# CONNECT MAIN STREET

## VOLUME II: CONCEPTUAL PLANS

## Public Improvement Plan Comment Statement

Figure 7-3: Public Improvement Plans - Sheet 3

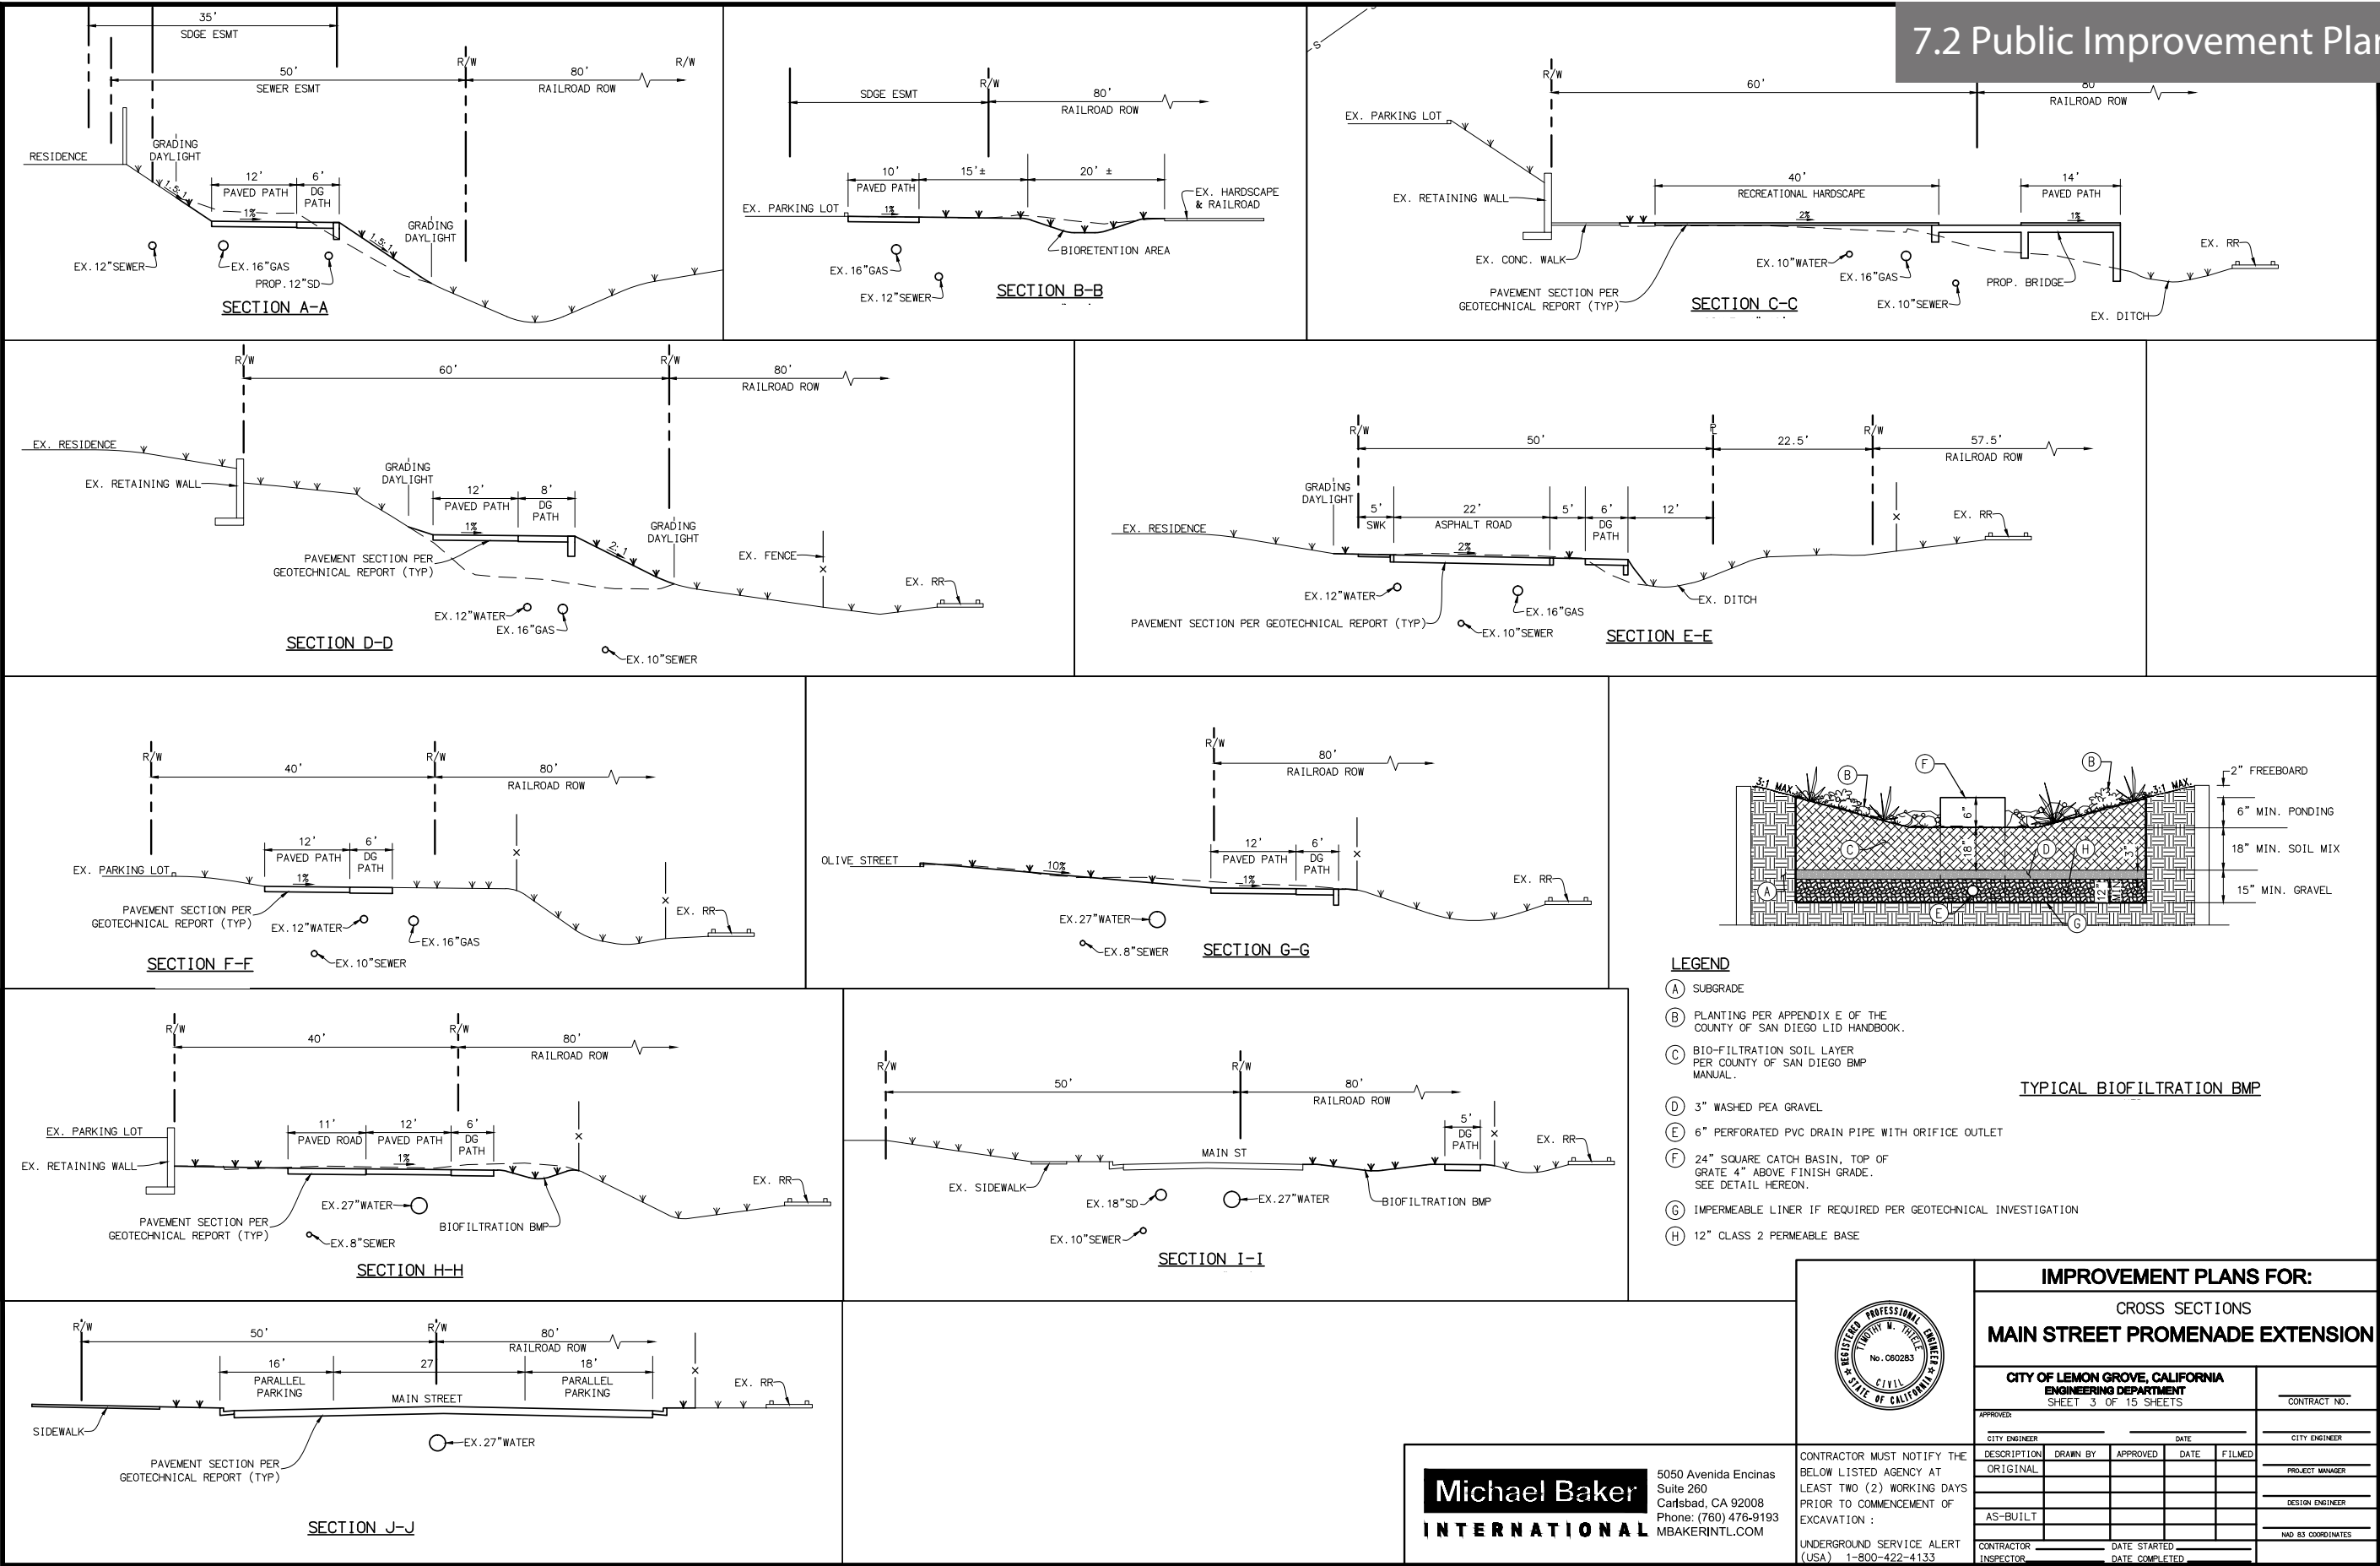
**Comment U-10:** On Section C-C, note the existing 10" water line between Massachusetts and San Pasqual St. is to be abandoned by Helix (reference sheet 3 and various sheets).

**Comment U-22:** On Section D-D on sheet 3, is this added fill below the DG path? If so, how deep and long is the fill?

**Comment D-8:** The typical bioretention detail on Sheet 3 needs to be made more consistent with the standard detail in the BMP Design Manual. The differences are:

**Comment D-10:** Note F on the typical bio filtration BMP detail on Sheet 3 states that the catch basin should be installed such that top of grate is 4" above finish grade. Typically, about 3" of mulch is included in the landscape design for bioretention areas. If mulch is being provided, either show the mulch as another layer on the detail so that it is clear that the ponding depth is from the top of the mulch to the top of

**Comment D-16:** Note 9 refers to an O" curb detail on Sheet 3 with no detail.

**Comment D-17:** Section E-E on Sheet 3 appears to imply that the existing ditch/channel will be partially filled. That would appear to reduce the channel's cross section. If the channel cross section is going

Figure 7-4: Public Improvement Plans - Sheet 4

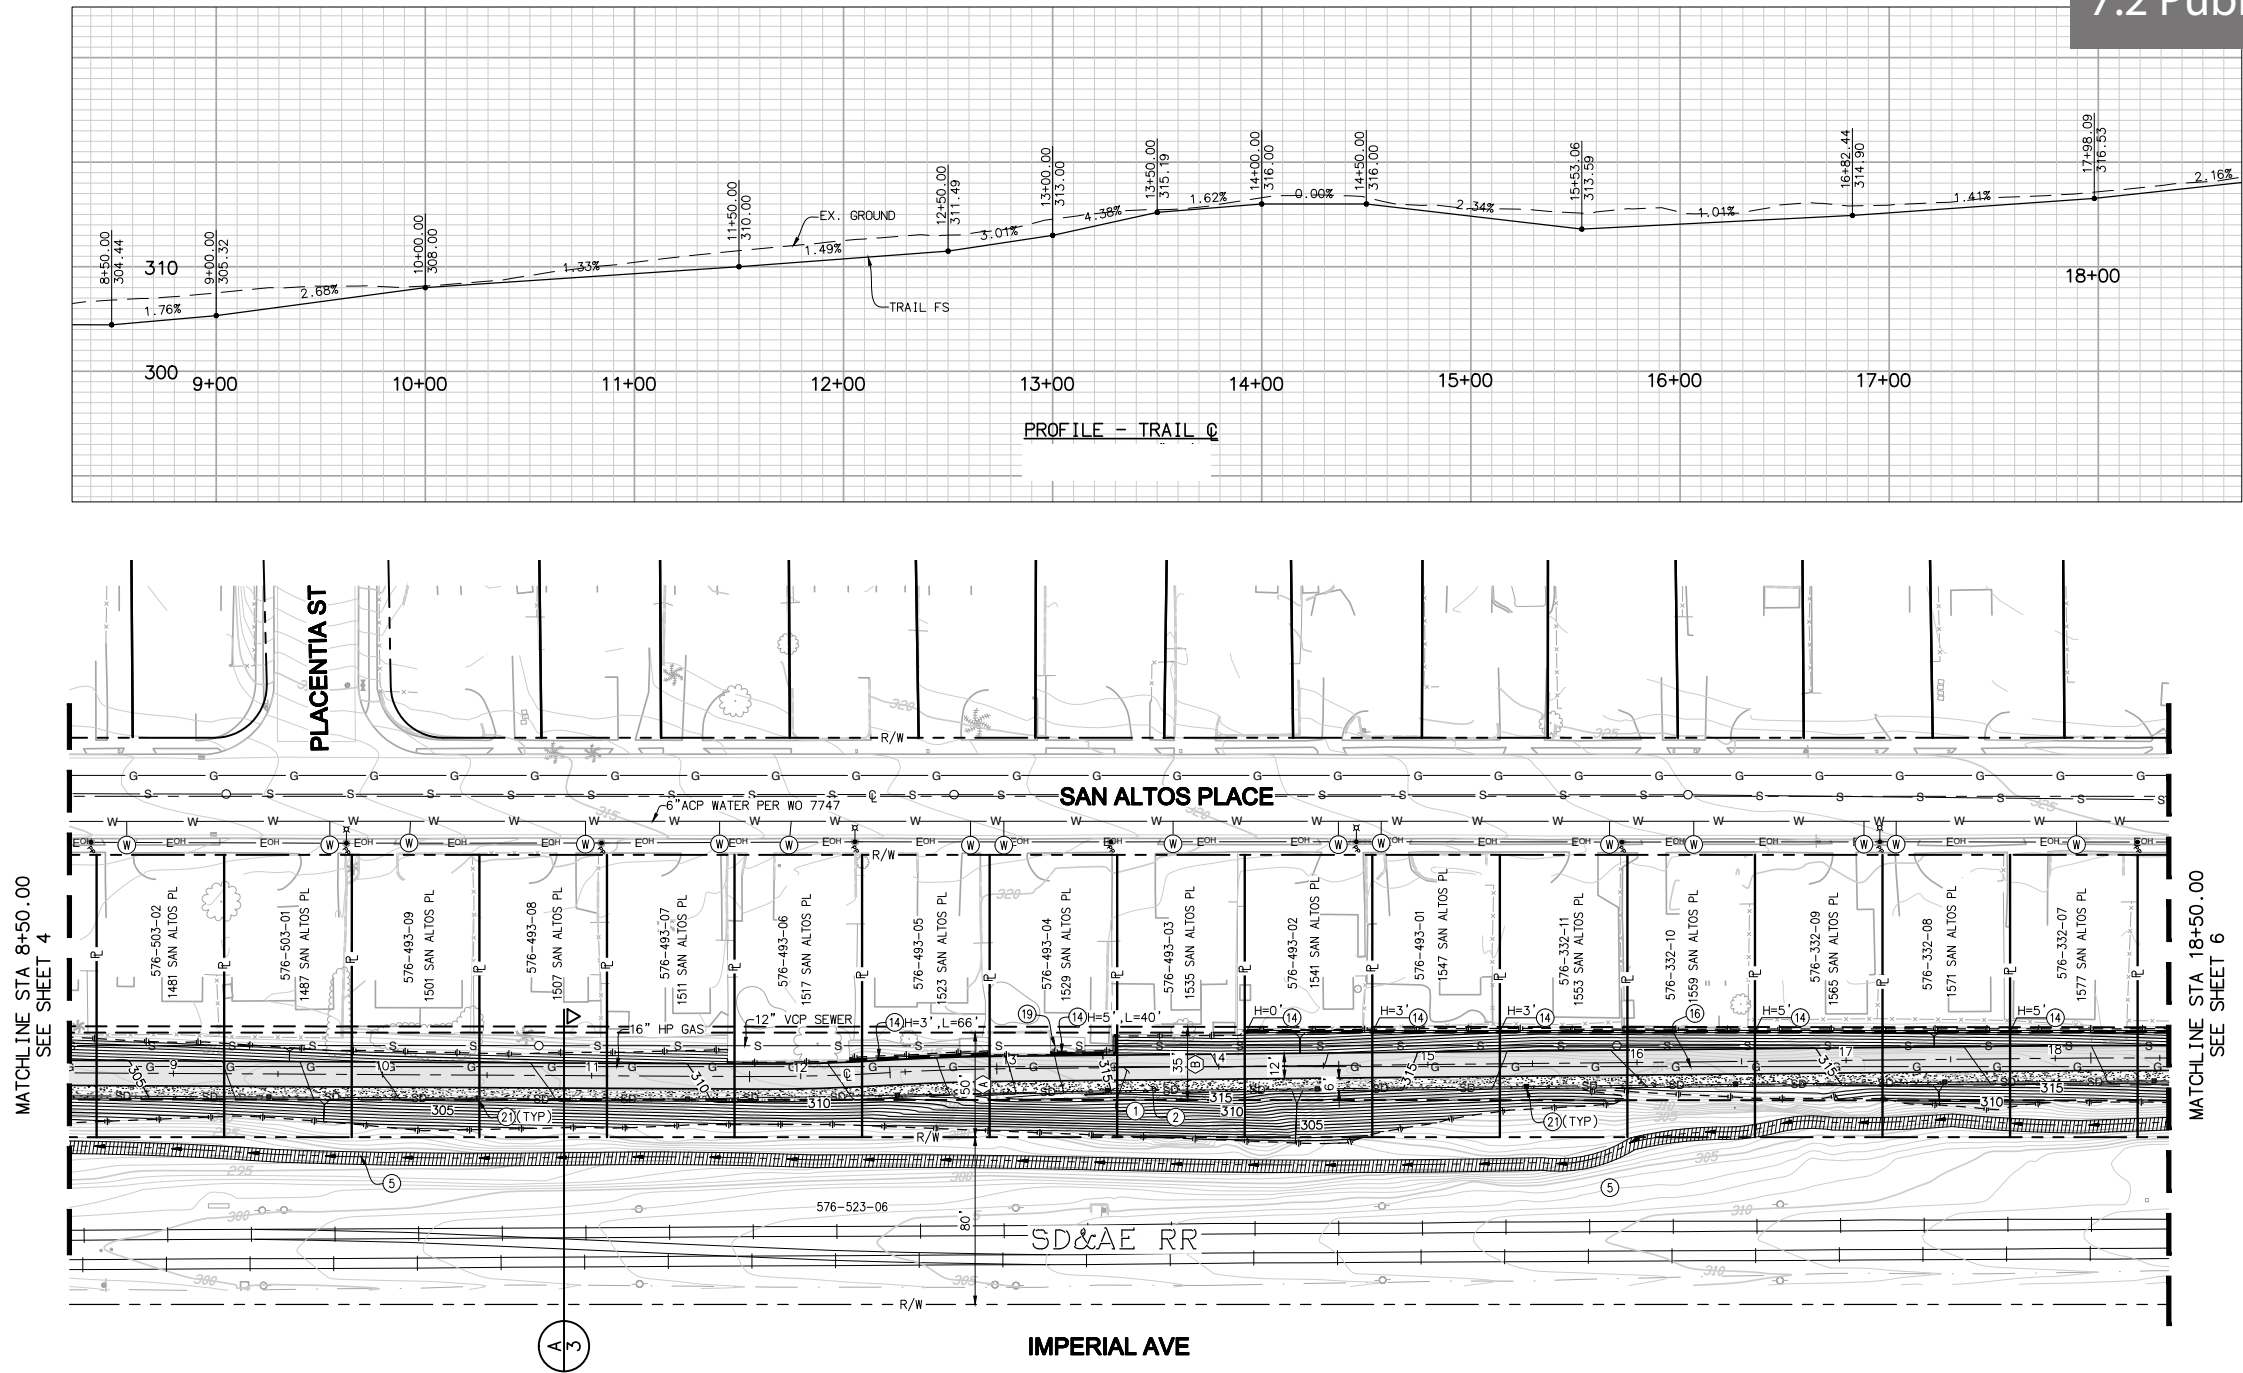
**Comment F-3:** Show all existing and proposed lighting. Ensure lighting is per City standards (reference sheet 4).

**Comment D-12:** Verify that only one 24" catch basin outlet is needed to convey high flows in the larger bio filters, in particular the bio filter on Sheet 4 (6,900 sf), the bio filter that spans Sheets 9 and 10 (3,800 sf), the bio filter that spans Sheets 13 and 14 (4,150 sf), and the bio filter on Sheet 15 (3,960 sf).

**Comment D-21:** Consider adding a cross section for Sheet 4, which has a bio filter and therefore is different than the area shown in Section A-A.

Figure 7-6: Public Improvement Plans - Sheet 6

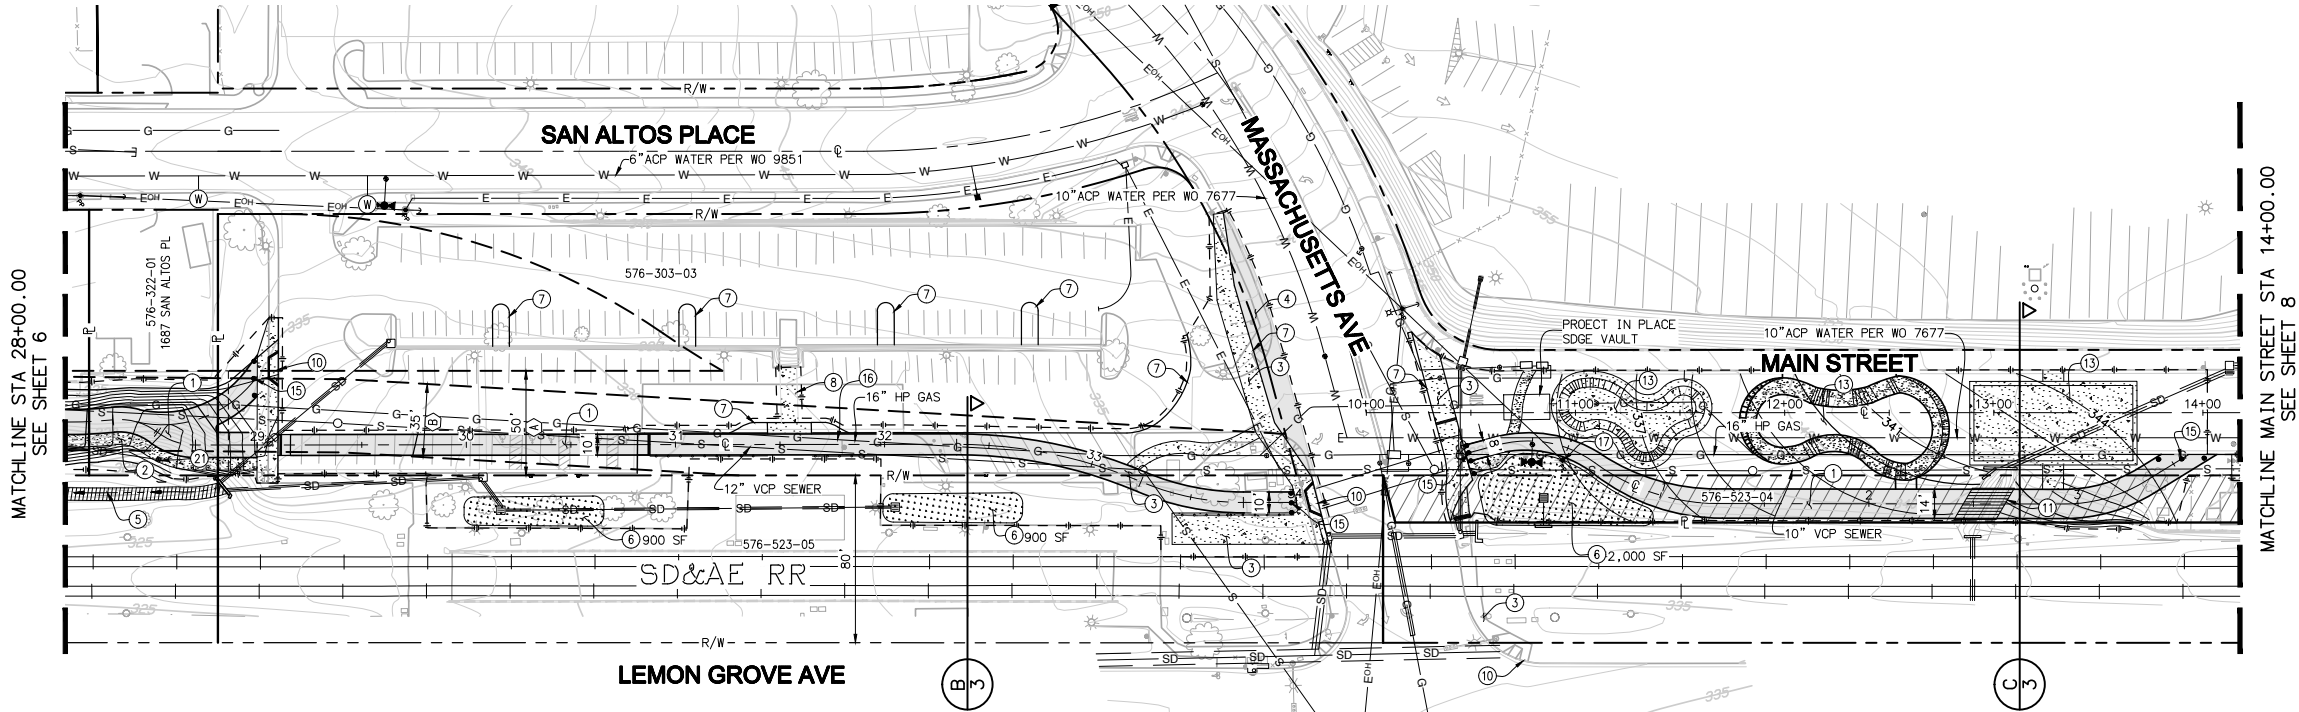
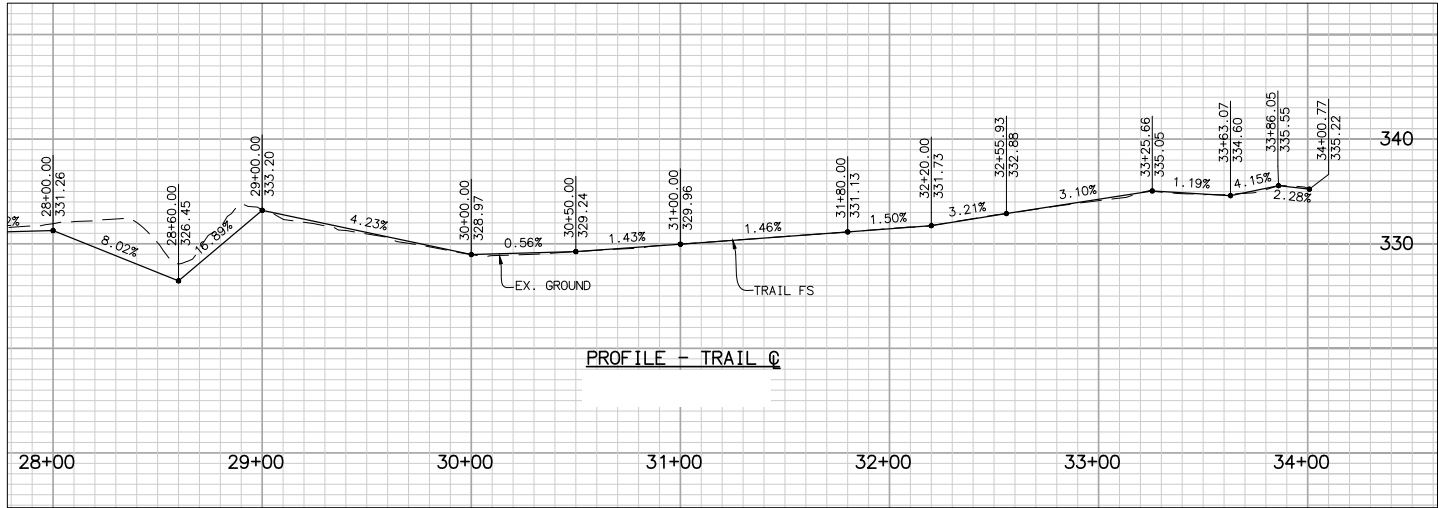
**Comment U-13:** Sheet 5 to Sheet 6: STA 7+40 - STA 23+60 from this station in the Improvement plans there will be a cut of at least 6" to 2 feet. This will impact SDG&E's existing 16" high pressure gas line, which is to have a minimum cover of 36". If grade cannot be adjusted, the pipe will need to be relocated. Since the pipeline was installed within an easement, relocation expenses will be on the City of Lemon Grove.
